REVISION 11/01/18

FY 2019-20 STANDARD PLANS

WIND AND HANGER BEAMS FOR OVERHEAD SIGNS

700-030 1 of 1

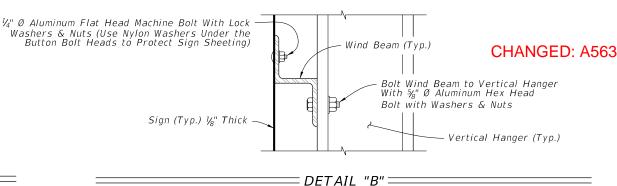
CORRECTED: "6 Beams"
